## REVISED RESPONSE TO REQUEST FOR ADDITIONAL INFORMATION

### APR1400 Design Certification

Docket No. 52-046

**RAI No.:** 45-7883  
**SRP Section:** 07.09 – Data Communication System  
**Application Section:** 07.09  
**Date of RAI Issue:** 06/23/2015

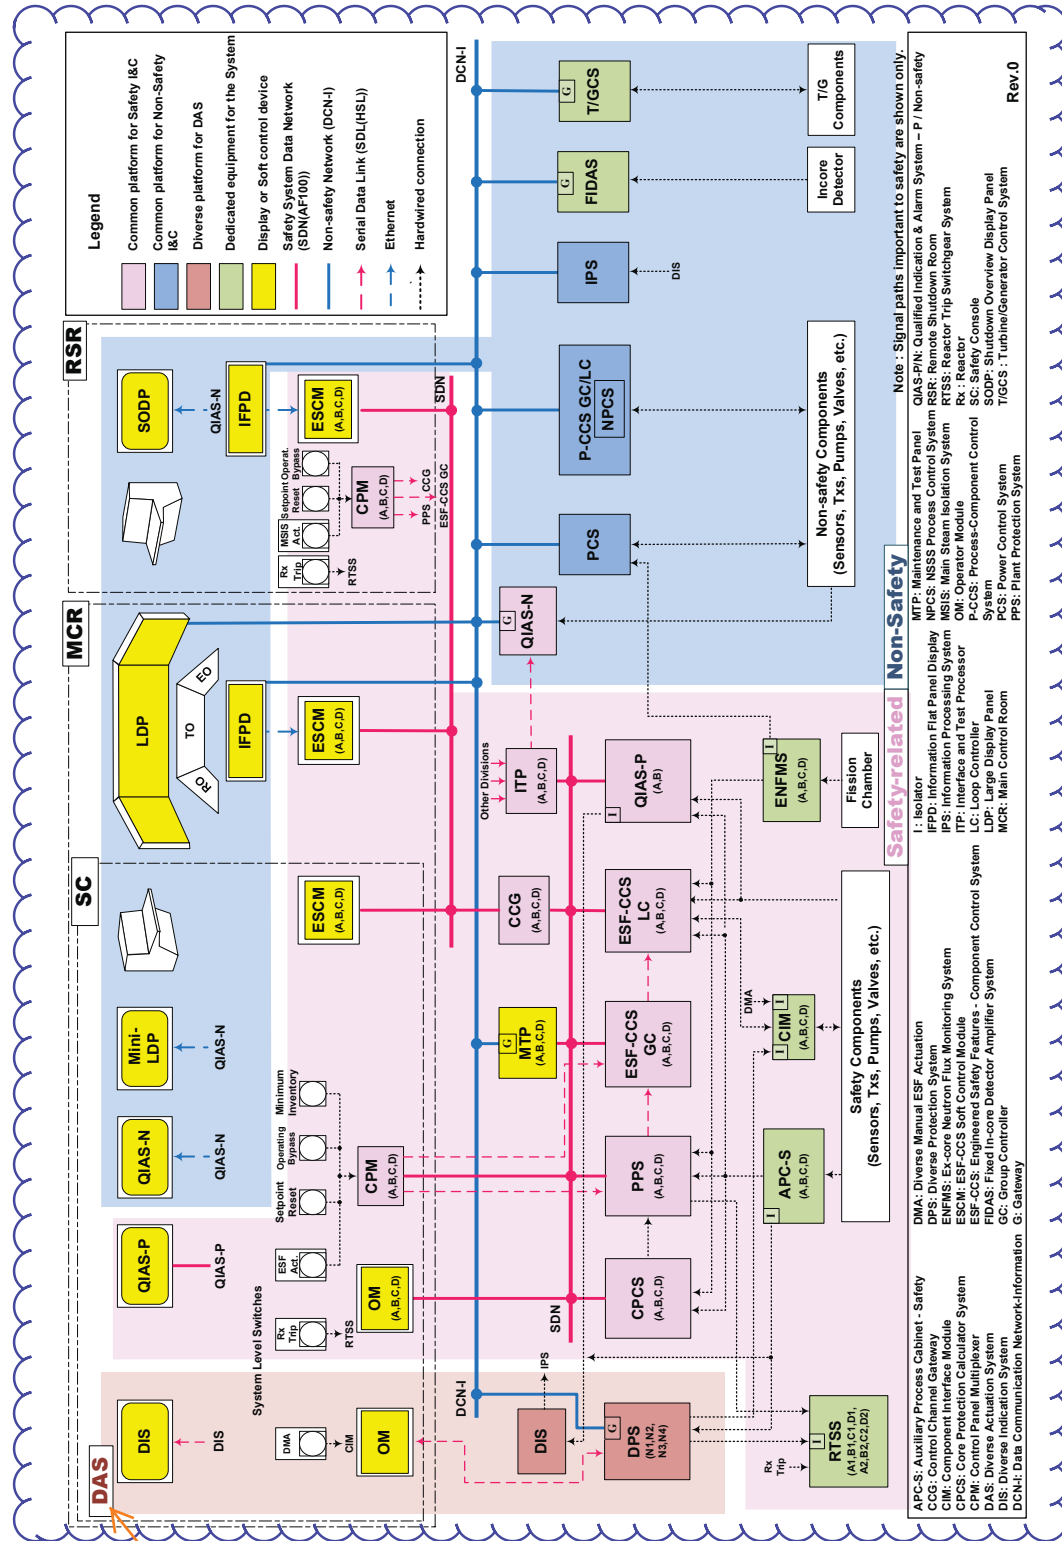
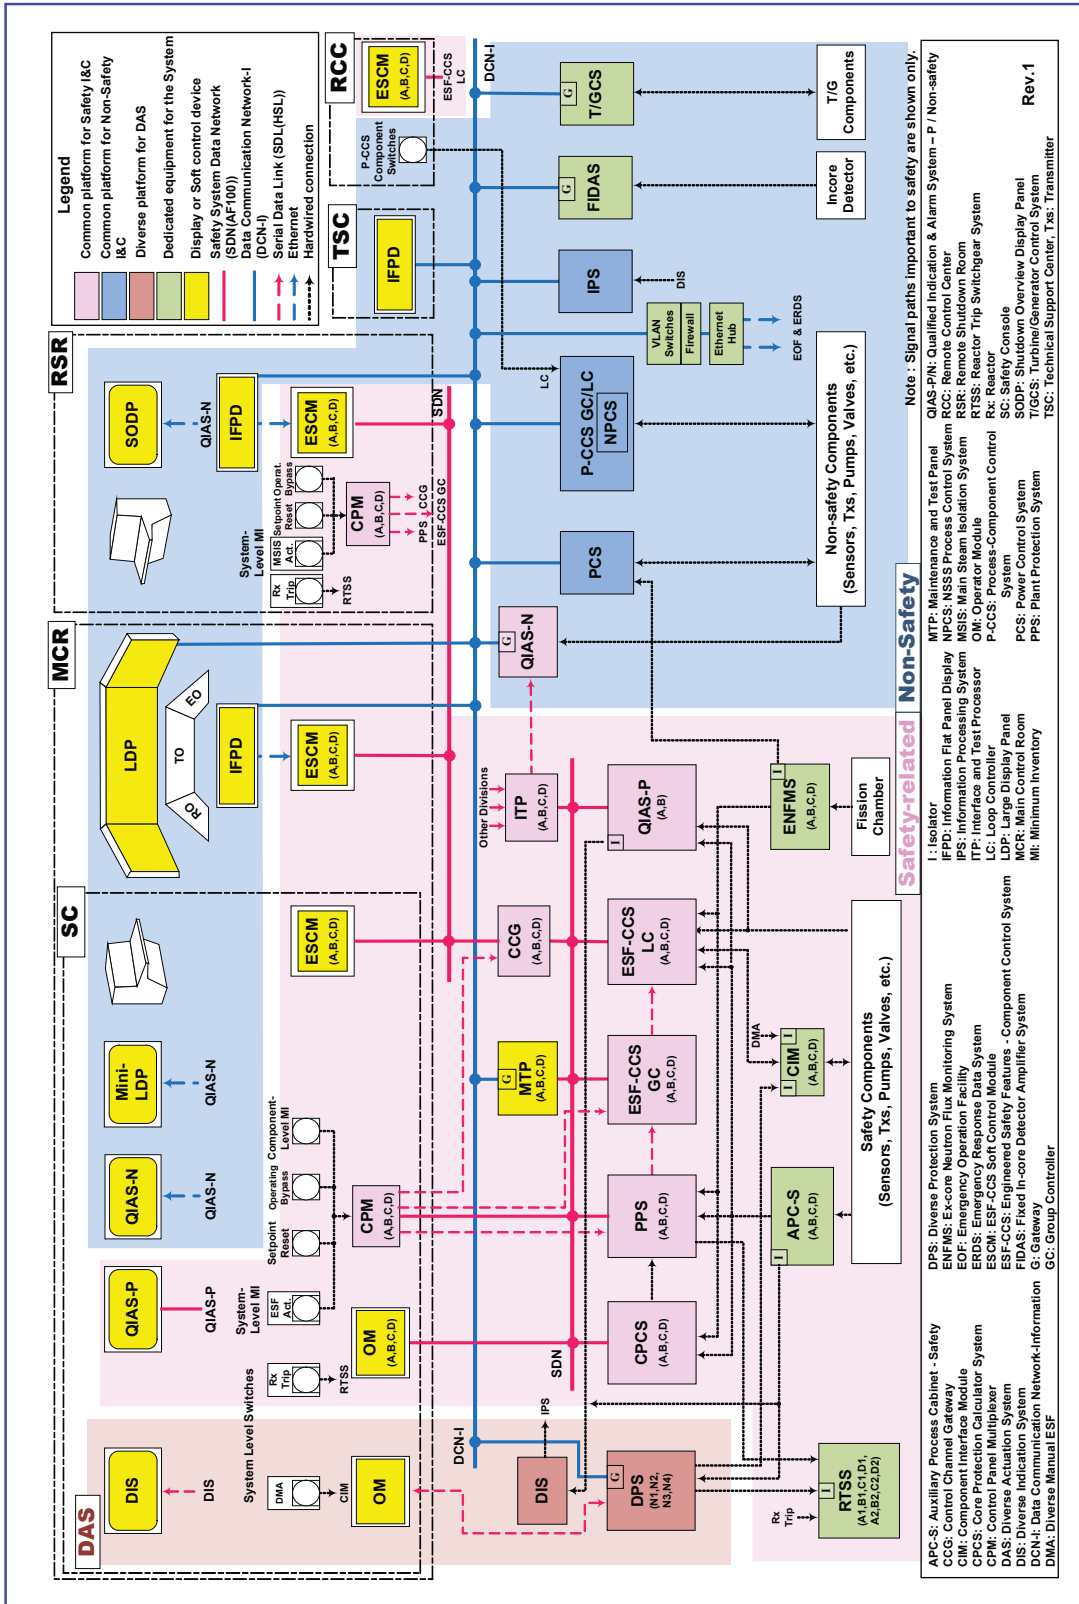
A description of the communication with external interfaces, such as the Emergency Operations Facility, will be added in a new section (Section 4.6.2.7). The corresponding interface will be shown on Figure 4-1 of the Safety I&C System Technical Report.

Sections 4.2.4, 4.3.4, 4.4.4.12, 4.5.3, 4.8.2, and Figure 4-1 of the Safety I&C System Technical Report will be revised and Section 4.6.2.7 will be added as indicated in the attached mark-up.
